REMARKS

Claims 1, 4-8, 10, 11, 15 and 16 are pending in the present application. Claim 1 has been amended and claim 12 has been canceled by the present Amendment.

FIG.2
RELATED ART

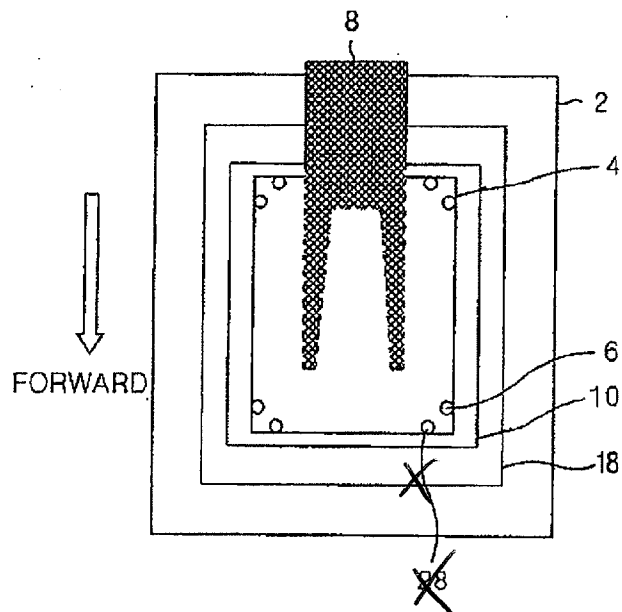
Regarding the rejection of claims 1, 4-8, 10-12, 15 and 16 under 35 U.S.C. § 112, second paragraph, it is respectfully noted Figure 2 has been amended to remove the label 28 (i.e., a stopping pin) because it is clear the pointed to element is a lift pin 6 and not a stopping pin 28. Figure 3 properly illustrates the location of the stopping pins 28 used to stop the substrate 4.

FIG. 5

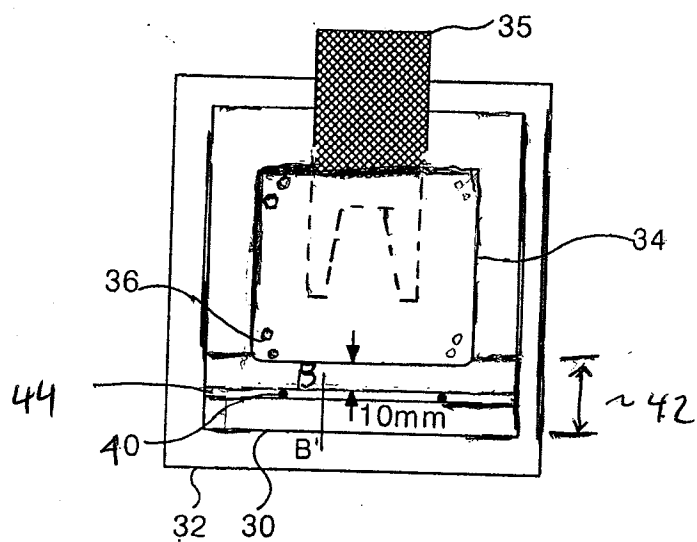
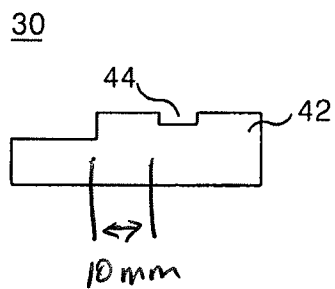
Regarding the objection to the drawings, it is respectfully noted Figures 2, 3, 5, 6, 12A and 12B have been amended to address the concerns noted in the Office Action. For example, Figure 5 has been amended to clearly show the sliding portion 42 disposed at one edge of the susceptor 30. Figures 11A-11C also clearly show the sliding portion 42. Figure 6 has also been amended to show a length of the sliding portion 42, measured from the groove 44, is about 10 mm. Figure 5 already shows this dimension of 10mm for the sliding portion 42. Note, this dimension is particular advantageous because this dimension makes a transfer of the substrate 34 more stable than the background art dimension of only 5mm (see paragraph [0041] in the originally-filed specification). In addition, because the dimension of the sliding portion is 10mm, the substrate 34 stably slides along the sliding portion 42. This sliding action, although beneficial because there is a more stable transfer, results in a problem that excess material from

Therefore, it is respectfully submitted the drawings show the sliding portion 42, the stopping pins 40, the groove 44 and the claimed dimension of 10mm.

Thus, as shown in Figures 11A-11C, 12A and 12B, the robot arm 35 supports a portion of the glass substrate 34 with a non-supported edge portion freely hanging over the robot arm 35 such that as the robot arm 35 moves in a forward direction to transfer the glass substrate 34 onto the susceptor 30, the non-supported edge portion of the glass substrate 34 slides on the sliding portion 42 of the susceptor 30 and is stopped by at least one stopping pin 40 located at the stopping position. These figures also illustrate the groove 44 formed in the sliding portion 42 of the susceptor 30 at a location of the at least one stopping pin 40 for receiving material 45 resulting from sliding of the glass substrate 34 on the sliding portion 42 of the susceptor 30. Figures 5 and 6 also illustrate a length of the sliding portion 42, measured from the groove 44, is about 10 mm.

FIG. 6

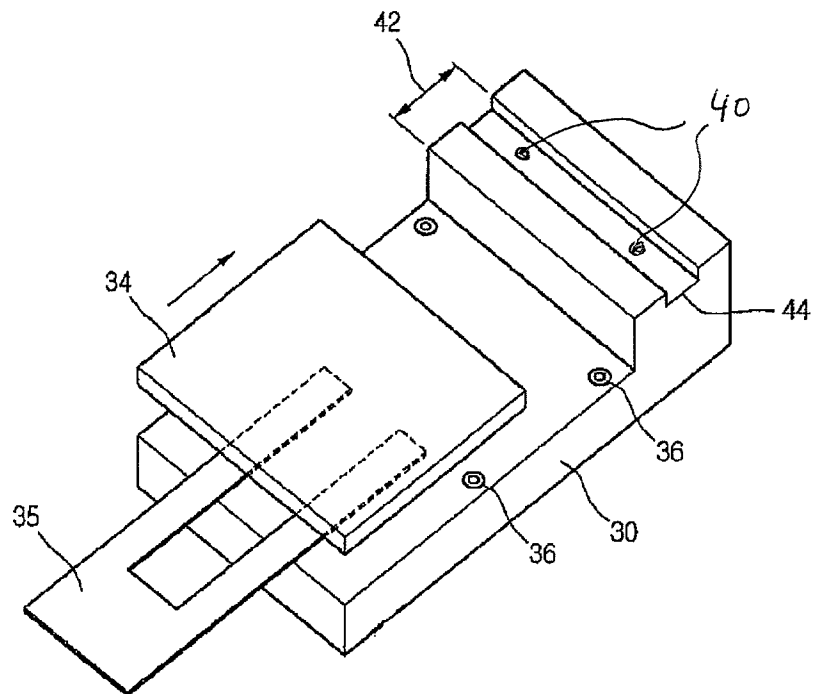
Also, with regard to claim 12 (which has now been included in claim 1), the second planar portion being horizontally contiguous with the first planar portion such that the first and second planar portions of the susceptor form a stepped-shape is shown in Figures 6-10. The second planar portion is the top portion of the susceptor 30 including the sliding portion 42 and the groove 44. The lower portion of the susceptor 30 corresponds to the first planar portion (and as shown the second planar portion is vertically above the first planar portion and horizontally contiguous with the first planar portion such that the first and second planar portions of the susceptor form a stepped-shape). Also, regarding the rejection of claim 15, as discussed above, claim 15 does not recite that the robot arm 35 is configured to incline the glass substrate 34 at 85 degrees. Rather, claim 15 recites that the incline of the non-supported edge of the glass substrate is substantially 85 degrees from a vertical when sliding the glass substrate on the sliding portion of the susceptor, which is shown in Figures 11A-11C.

FIG.12A

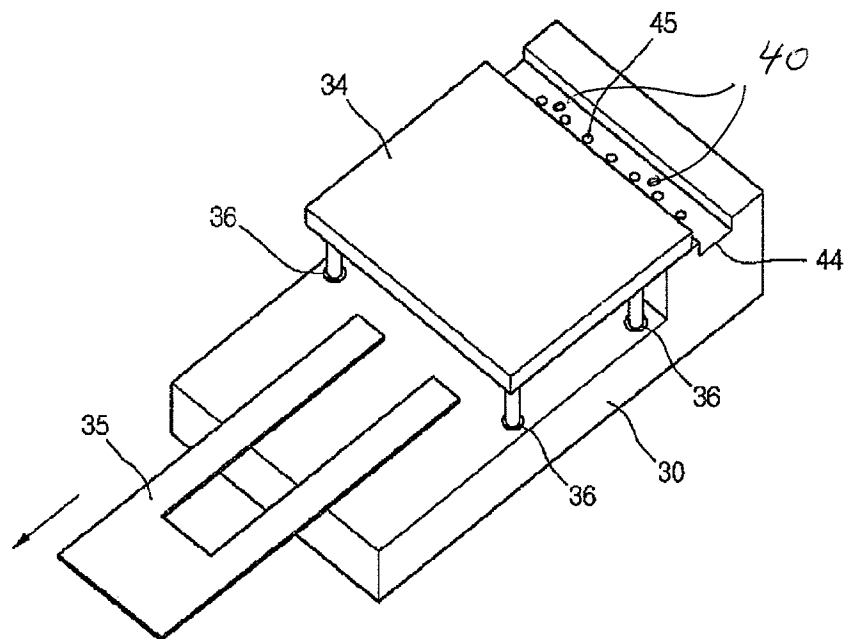
The present invention solves the problems of the related art by increasing the sliding portion of the susceptor to about 10mm and also by including a groove 44 in the susceptor 30 to catch scraped off material (Figure 11A-11C illustrate the material 45 being scraped off by the sliding substrate 34 and scraped into the groove 44). In addition, the stopping pins 40 are placed within the groove 44 (Figures 12A and 12B have been amended to clearly illustrate this feature). Note that original Figure 5 illustrates the stopping pins 40 being within the groove 40, and thus the amendments made to Figures 12A and 12B are not new matter.

In addition, regarding the objection to Figures 12A and 12B only showing less than half of the susceptor, it is respectfully noted Figures 12A and 12B are partial views of the susceptor and are not intended to show the entire susceptor (Figure 5 illustrates the entire susceptor from a top view perspective). In addition, it is respectfully noted that the stepped-portion of the susceptor 30 (Figures 6-10 clearly illustrate the stepped-portion) occurs at only one edge of the susceptor and is not around an entire circumference of the susceptor.

Also, Figures 11A-11C, 12A and 12B are diagrams used to illustrate the loading and unloading of the substrate 34. A detailed explanation of the loading and unloading process will now be given with respect to Figures 11A-11C, 12A and 12B.
